**Re: TLC Pet and Uptown Cat Hospital
1300 Wyoming Blvd NE
Request Permanent C.O. - Accepted
Engineer's Stamp dated: 10-29-14 (J20D027)
Certification dated: 5-27-15**

**Re: TLC Pet and Uptown Cat Hospitals, 1300 Wyoming Boulevard, N.E.
Traffic Circulation Layout
Engineer's/Architect's Stamp dated 10-06-14 (J20-D027)**

**Re: TLC Pet and Uptown Cat Hospitals
1300 Wyoming Boulevard, N.E.
Request for Traffic Circulation Layout (TCL) for Building Permit Approval**

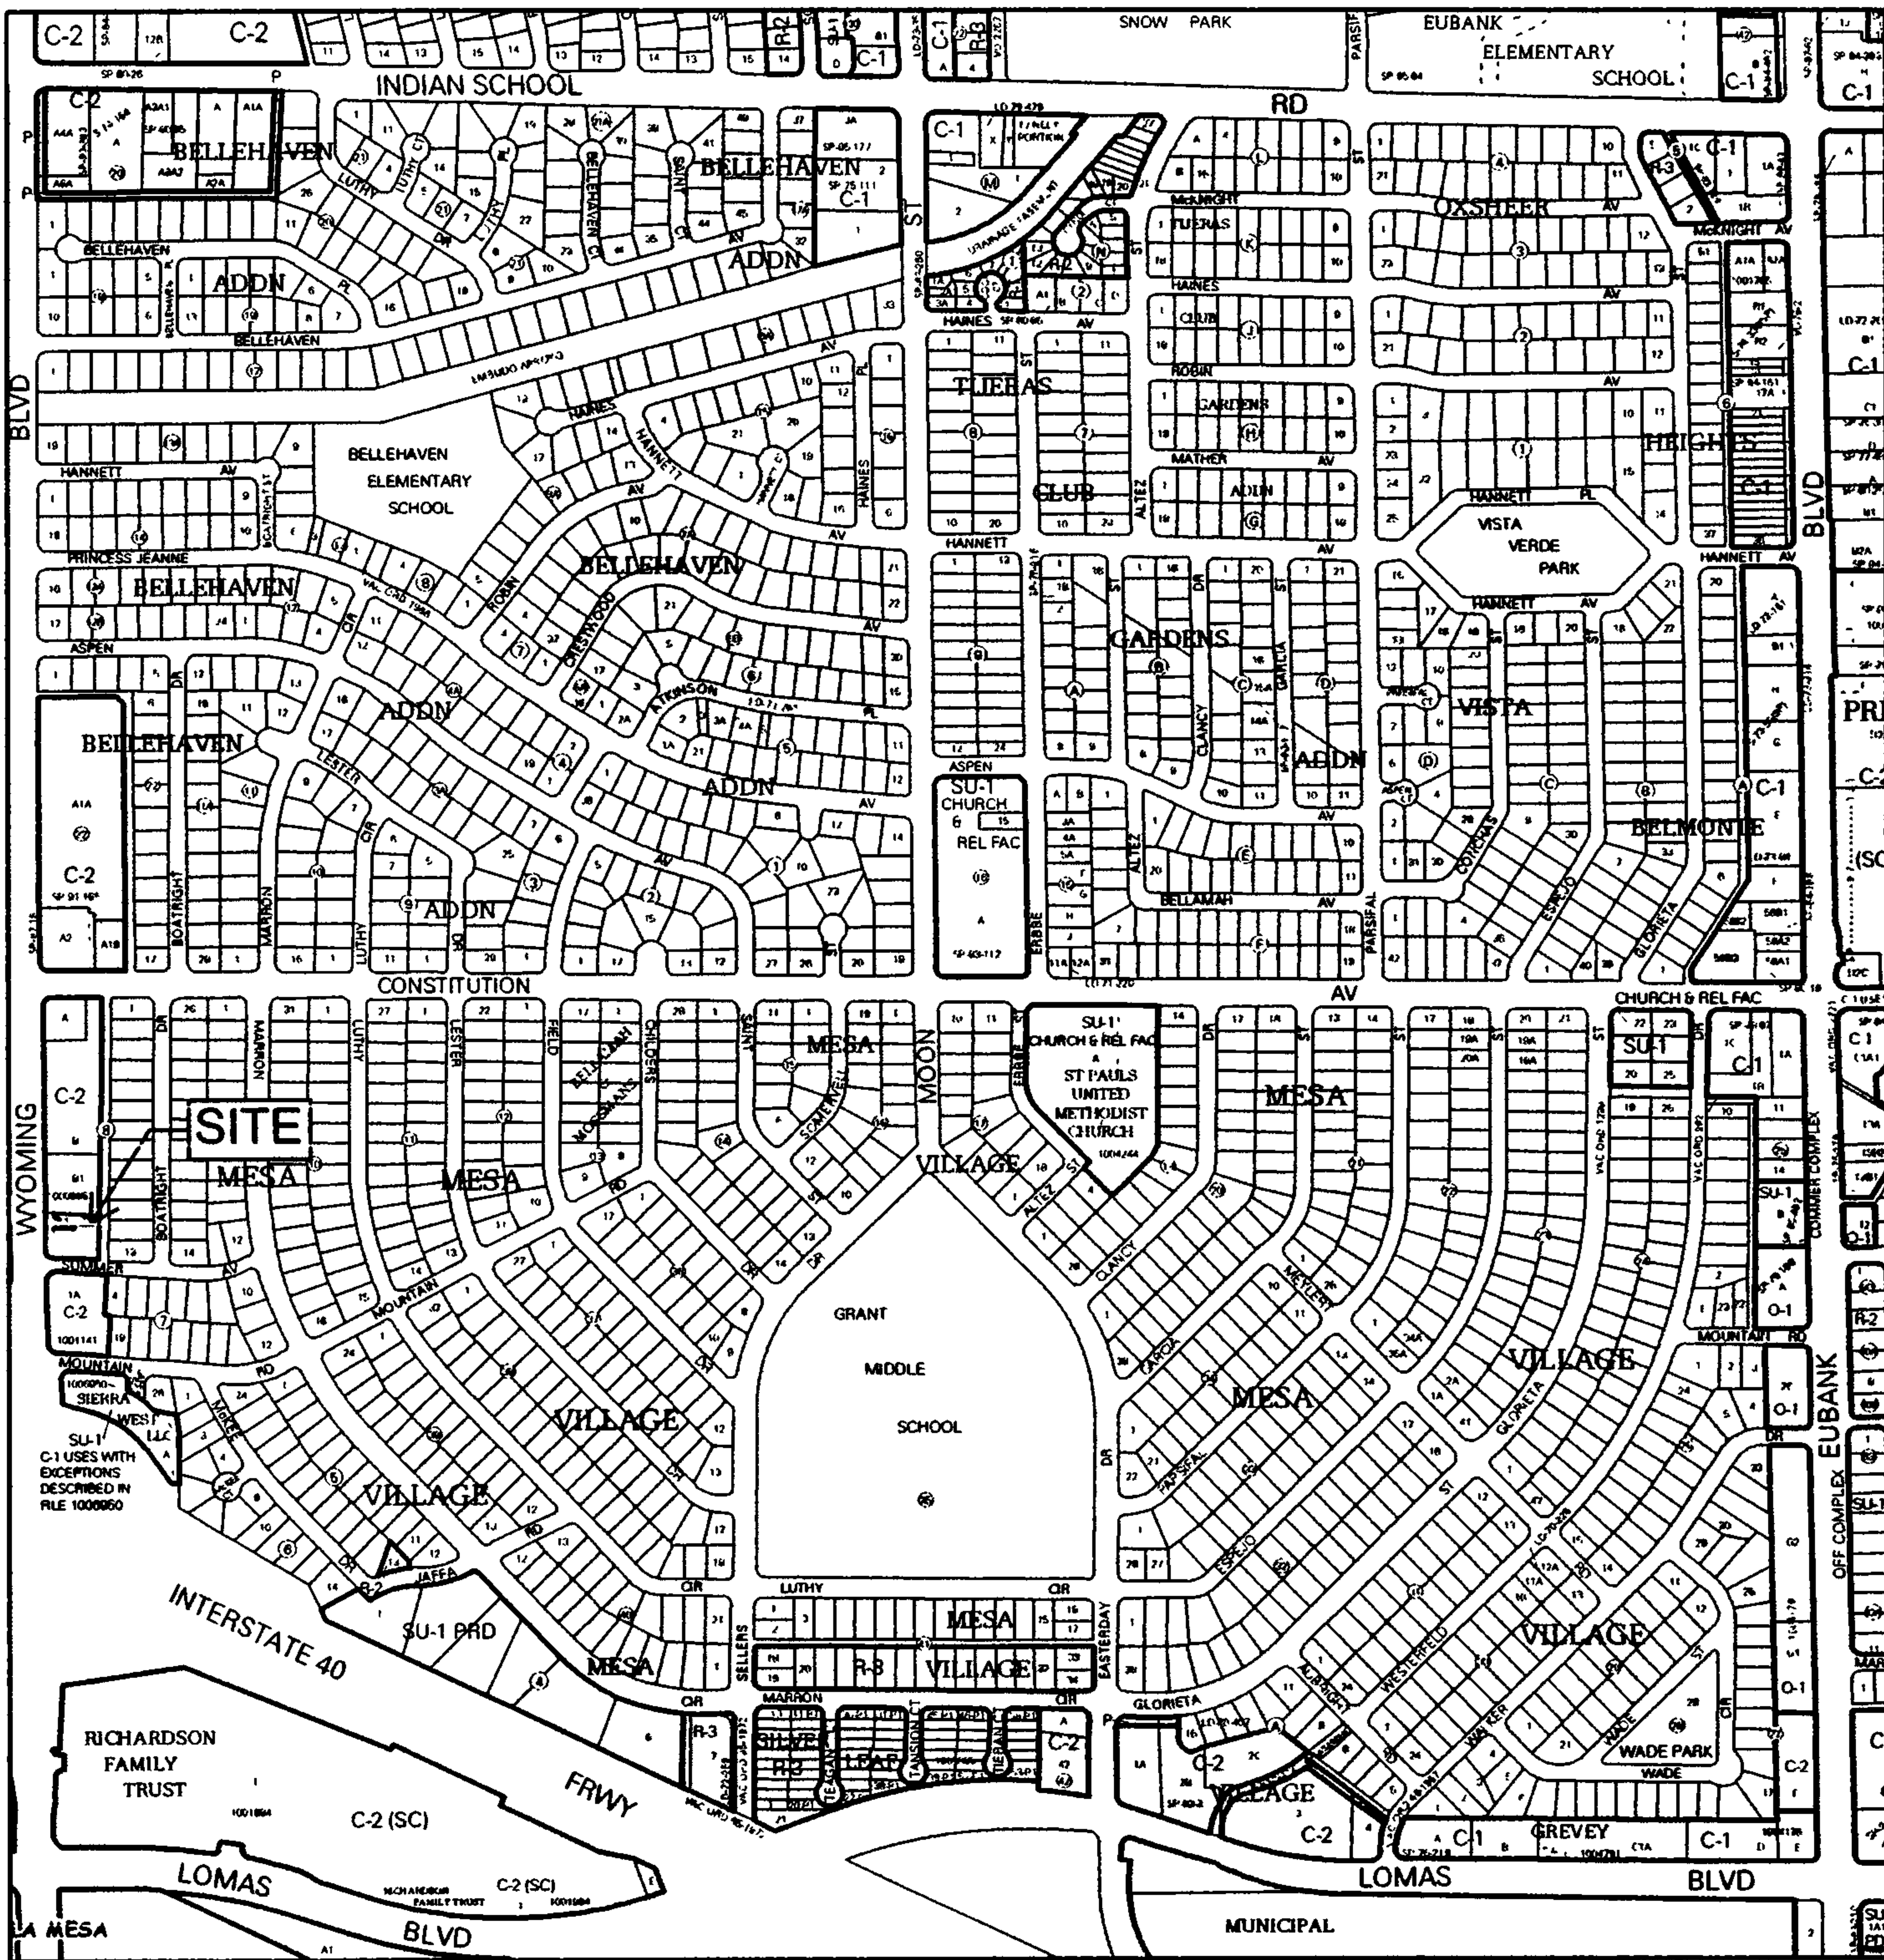
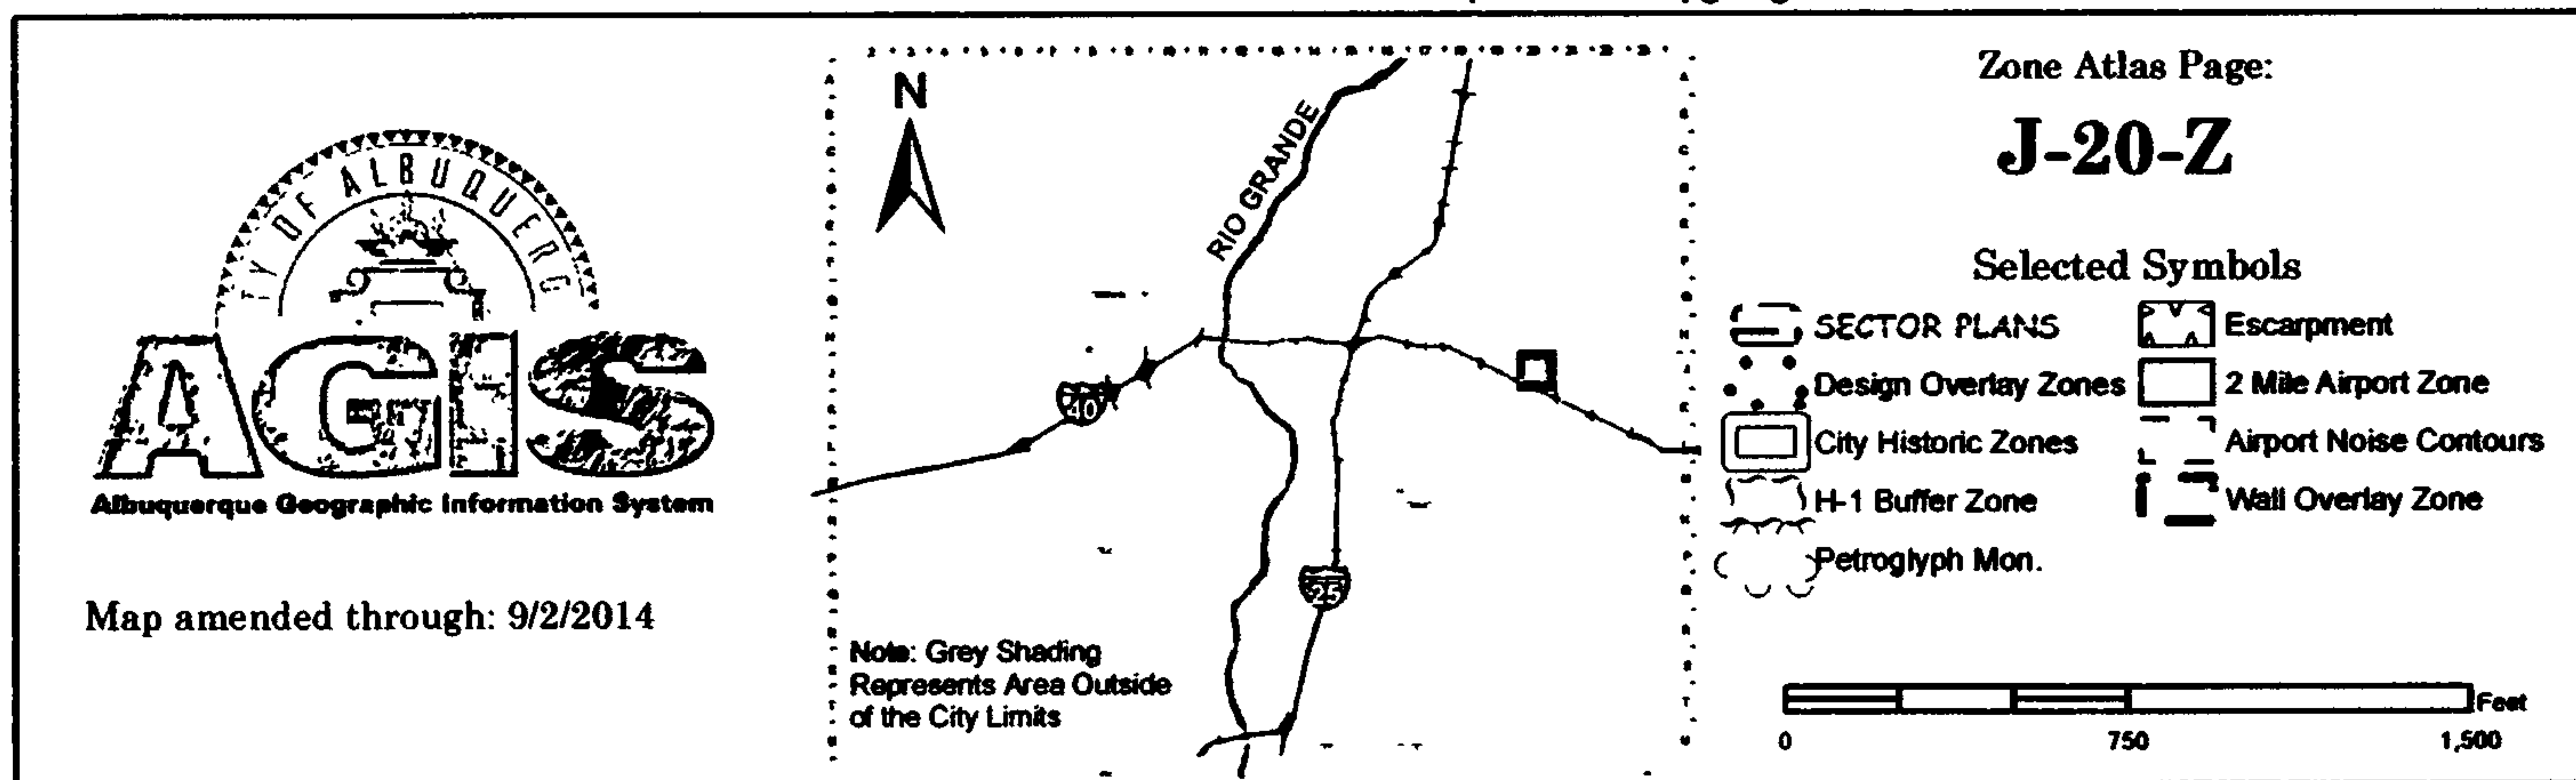
1. Include approval from Solid Waste on the location of the refuge enclosure.
2. If 15-foot radii cannot graphically be achieved for passenger vehicle maneuvering in and out of Summer Avenue, just increase the radii to what you can provide given the site constraints without having to do any access construction within the right-of-way. (In this case, the radii don't absolutely need to be as large because of the existing 31-foot wide curb cut.)

3. The proposal to move the curb within the site to line up with the south edge of the existing drivepad on Wyoming Boulevard will work fine.
4. The handicapped ramp location and dimensioning still needs to be worked on. The ramp needs to be drawn to reflect a 12:1 slope for a 6-inch curb, and there needs to be a minimum dimension of 5 feet from the back of the ramp to the building. (This is so the wheelchair can make the 90-degree turn within a 5-foot space to head over to the other front entrance to the west if necessary. Show this 5-foot dimension on the plan.) The ramp also needs to line up with the cross-walk.

1. Please provide a vicinity map with the location of the site development in relation to surrounding streets.
Vicinity map, indicating the project location, is now on the site plan.

2. Please provide a legend for the various line-types and hatching.
In lieu of a legend, the various line types (i.e. property lines) and hatches (i.e. new construction, existing construction and landscaping) are noted as such.

3. Identify the existing right-of-way width, medians, and street widths for Wyoming Boulevard and Summer Avenue.
Right-of way and street widths are noted for Summer Ave and Wyoming Blvd.

4. In addition to being too close to the Summer Avenue intersection, the existing drivepad on Wyoming Boulevard does not match up with the driving aisle. Revise the existing drivepad to match up with the driving aisle along the south side of the access.
Per our subsequent discussions, the curb returns from the drive aisle have been modified to match up with the existing drive pad.

5. On the southwest corner of the parking lot make a correction from 3 Spaces to "2 Spaces @ 9'-0" = 18".
Correction made.
6. For Keyed Note 16, the ADA van accessible sign must have the required language per 66-7-352.4C NMSA 1978 "Violators Are Subject to a Fine and/or Towing."
Keyed note 16 now includes this language.

7. The ADA access aisle shall have the words "NO PARKING" in capital letters each of which shall be at least one foot high and at least two inches wide placed at the rear of the parking space so as to be close to where an adjacent vehicle's rear tire would be placed (66-1-4.1.13 NMSA 1978).
This has been noted on the site plan.

8. See Figure 23.7.2 of the DPM for end of parking aisle islands Change the curb radii from 1 foot to 3 feet where shown on parking aisle islands near the end of the parking spaces. Curb radii should be 15 feet for passenger vehicle maneuvering.
Radii have been increased where possible.

9. Graphically, it appears that it will be difficult to incorporate a 6-foot wide flat ADA-accessible path in front of the door in addition to a ramp with a 12:1 slope. (Make sure that both the 12:1 ramp and a 6-foot pathway can be incorporated. The ramp is only drawn at a 5-foot length).
The drive aisle along the south side of the building has been reduced to 22', since parking only occurs on one side of the drive aisle, to allow for a greater sidewalk against the building, which also allows for 6' from the top of the HC ramp to the building. Additionally, the ramp detail indicates a 1:12 slope.

10. Call out curb height for Keyed Note 12. Keyed Note 12 needs to correctly point to curb for access off of Wyoming Boulevard.
Correction made.
11. For ease of refuse vehicle maneuvering, move the refuse at least a few feet to the east away from the curb.
Approval by the refuse department is indicated on the site plan.

12. Indicate what pavement thickness will be used for the parking lot.
Existing asphalt is to remain and only be resurfaced. Keyed note 5 indicates this.

13. The proposed landscaping at the access off of Summer Avenue may interfere with the sight distance. Provide clear site triangle. (See DPM Manual Page 23-74 of the DPM for Mini Clear Site Triangles for Driveways.)
Clear site triangles are indicated at the drive pad off of Summer Ave.

14. Please add the following note to the clear sight triangle: "Landscaping and signage will not interfere with clear sight requirements. Therefore, signs, walls, trees, and shrubbery between 3 and 8 feet tall (as measured from the gutter pan) will not be acceptable in this area."
Note included as General Note B.

15. Please specify the City Standard Drawing Number when applicable.
City Standards are noted where applicable.
16. Work within the public right of way requires a work order with DRC approved plans.
If right-of-way work is required, DRC plans will be produced. General Note D indicated that no public work is anticipated.

17. Please include two copies of the traffic circulation layout at the next submittal.
Included.
